MEETING OF THE MINTURN PLANNING COMMISSION Minturn, CO 81645 • (970) 827-5645

Wednesday, July 14, 2021 Regular Session – 6:30 PM

Hearing Date:	July 14, 2021
File Name and Process:	Faircloth Garage Addition / Variance Request
Owner/Applicant:	Heather Faircloth
Representative:	Tom Warzecha
Legal Description:	BOOCO Subdivision, Block F, Lot 12 and Part of Lot 13
Address:	261 Main Street
Zoning:	Old Town Mixed-Use (Old Town Character Area)
Staff Member:	Scot Hunn, Planning Director Madison Harris, Planner I
Recommendation:	Approval, with Conditions

Hearing Date:	July 14, 2021
File Name and Process:	Single-Family Residence Final Plan Review
Owner/Applicant:	Emily and Steve Hutton
Representative:	Michael Pukas, MPP Design Shop, Inc.
Legal Description:	Lot 14, Block 2, Booco's 2 nd Addition to Minturn
Address:	482 Eagle River Street
Zoning:	Old Town Character Area – Mixed Use Zone District
Staff Member:	Scot Hunn, Planning Director Madison Harris, Planner I
Recommendation:	Approval, with Conditions

GARAGE = 529 SQ. FT.

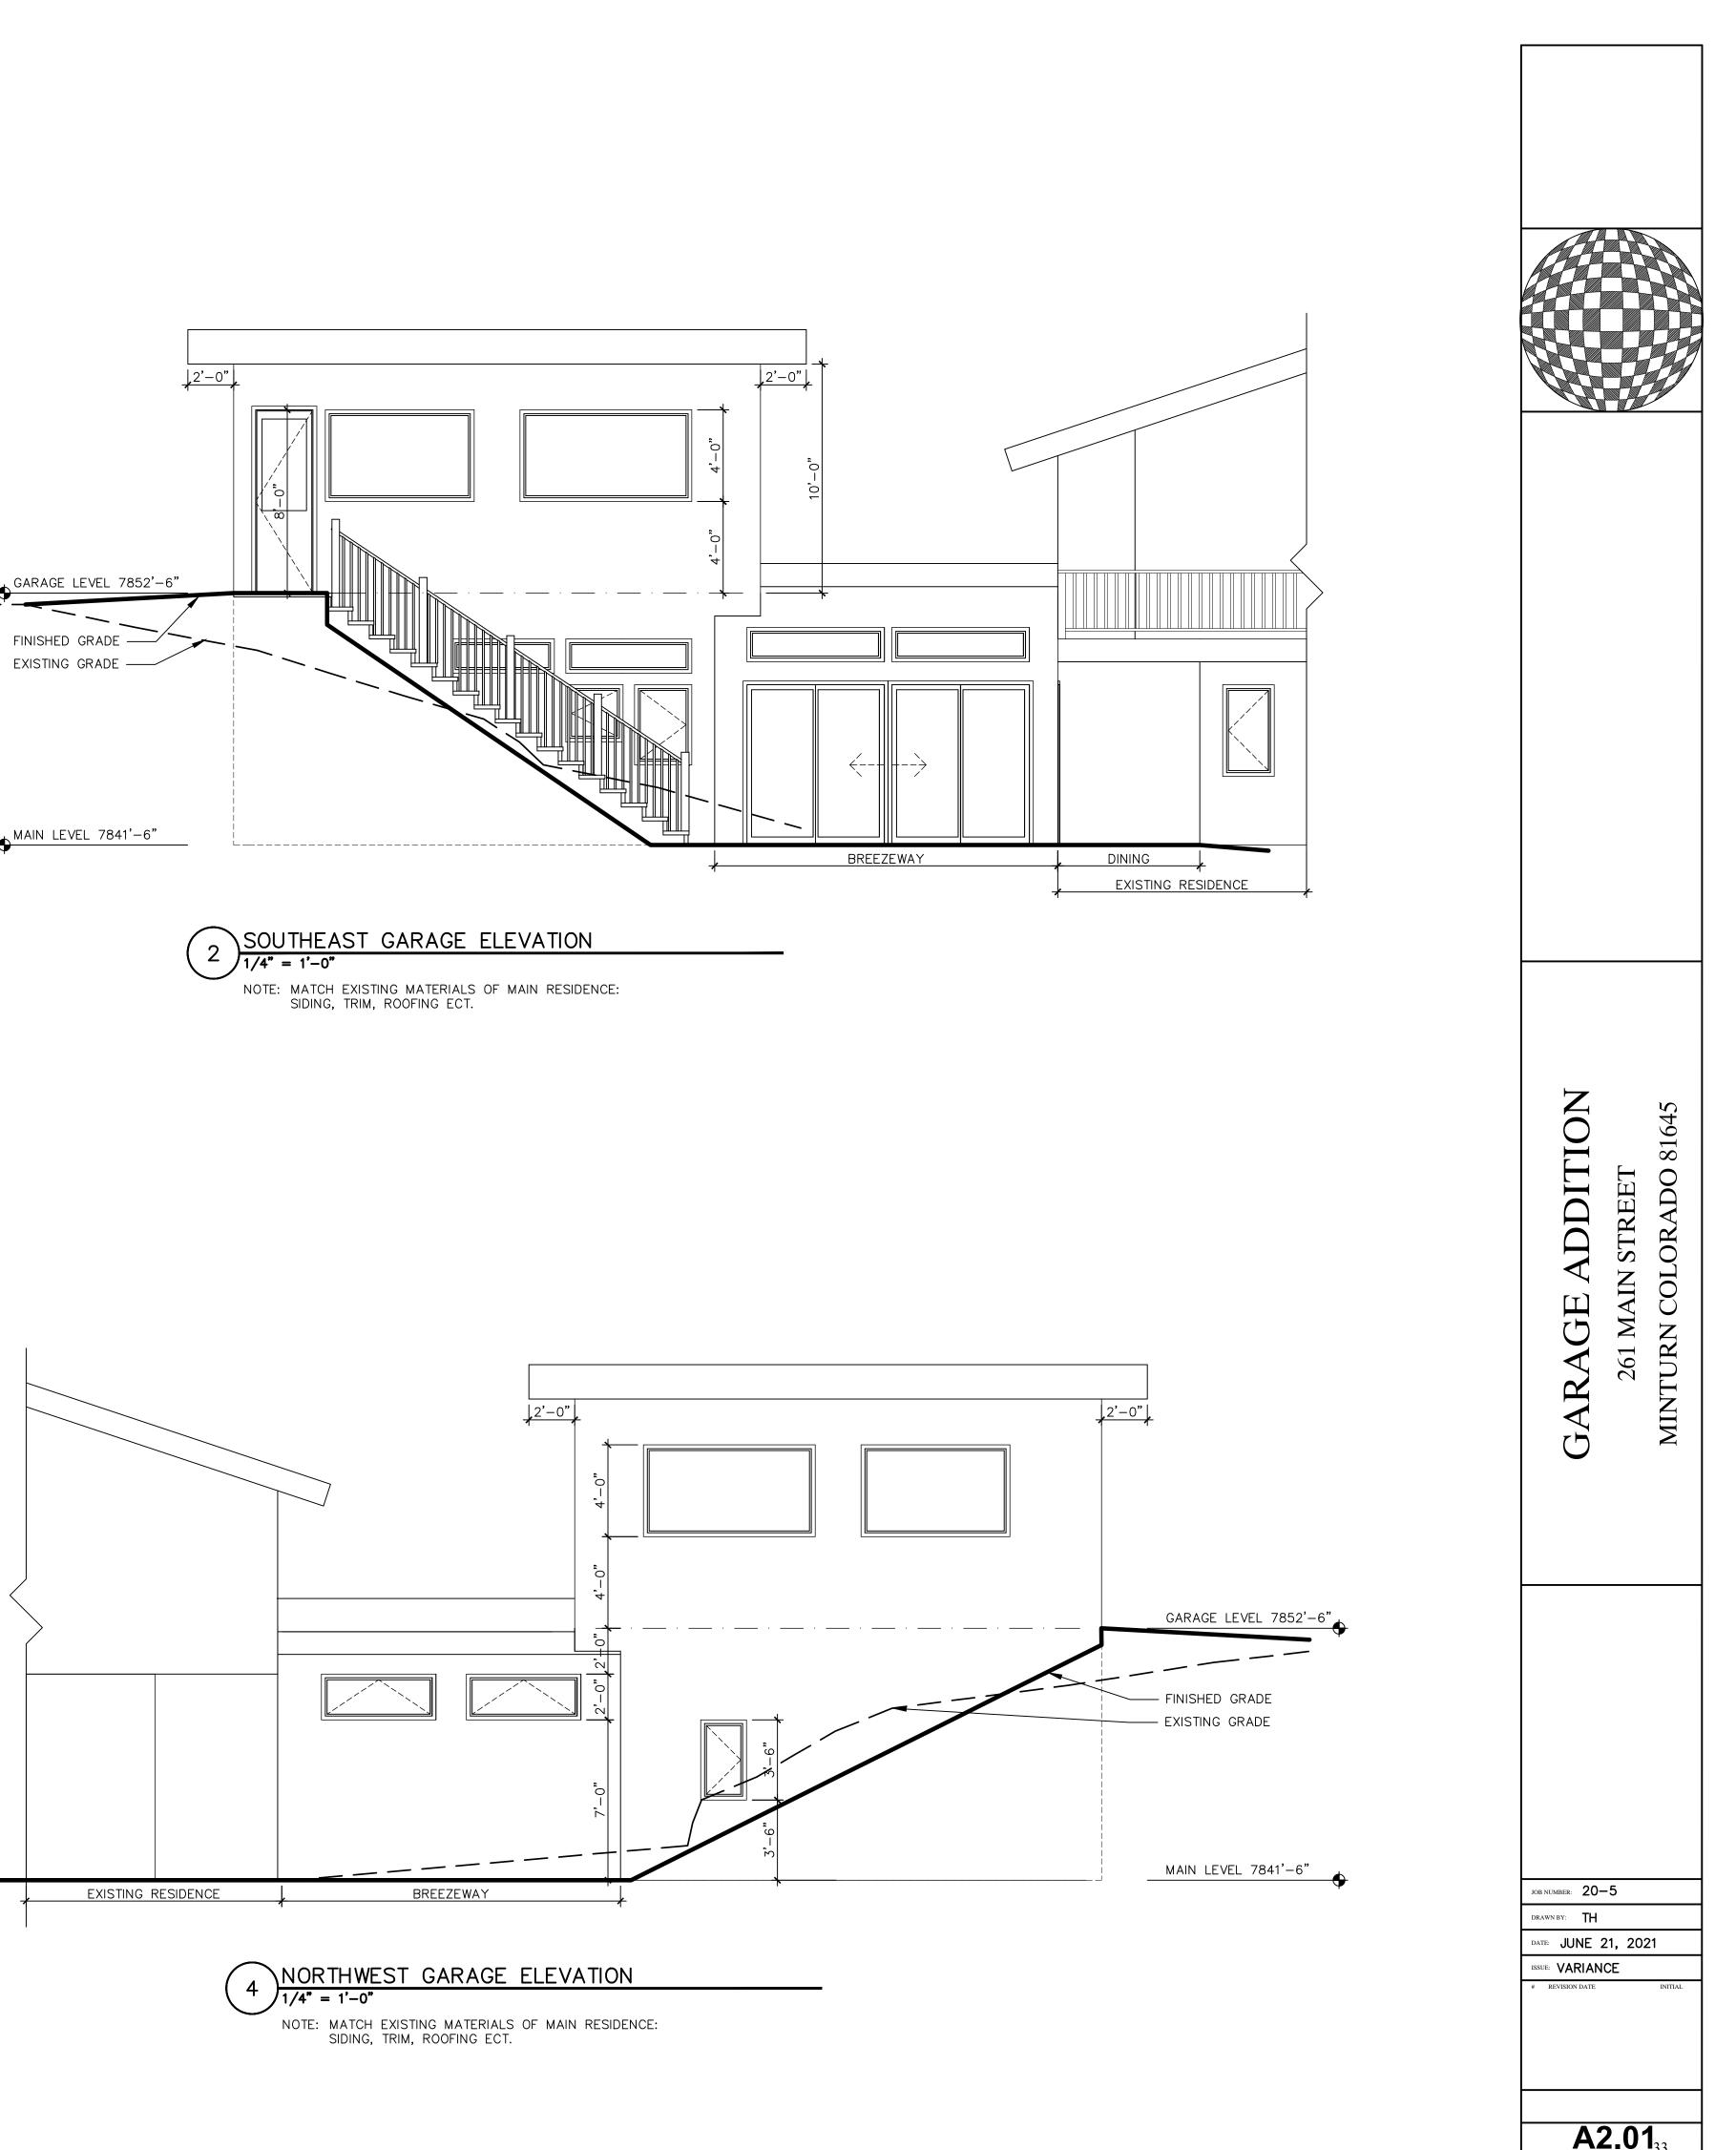
• Exterior Light Fixtures – the floor plans and elevations should be updated prior to building permit to show all exterior lighting locations as well as cut sheet/specifications.

The plans should be updated to show exterior light locations. Light fixtures and lighting solutions are to be dark sky compliant.

- 1. The Applicant shall provide final grading and drainage details, including an updated survey showing spot elevations, for review by the Town Planner and Engineer prior to the submittal for building permit.
- 2. The Applicant shall revise the site and/or floor plans to show all proposed exterior light locations and provide final cut sheets/specifications for proposed exterior light fixtures prior to or concurrent with building permit applications to ensure compliance with the Town's lighting standards as well as consistency with fixtures found on the existing residential structure on the subject property.
- 3. The Applicant shall revise the Final Plans to remove the breezeway and/or revise other aspects of the plan to reduce overall, total impervious surface coverage to no more than 60%.
- 4. The Applicant shall provide final details and dimensions for all proposed exterior
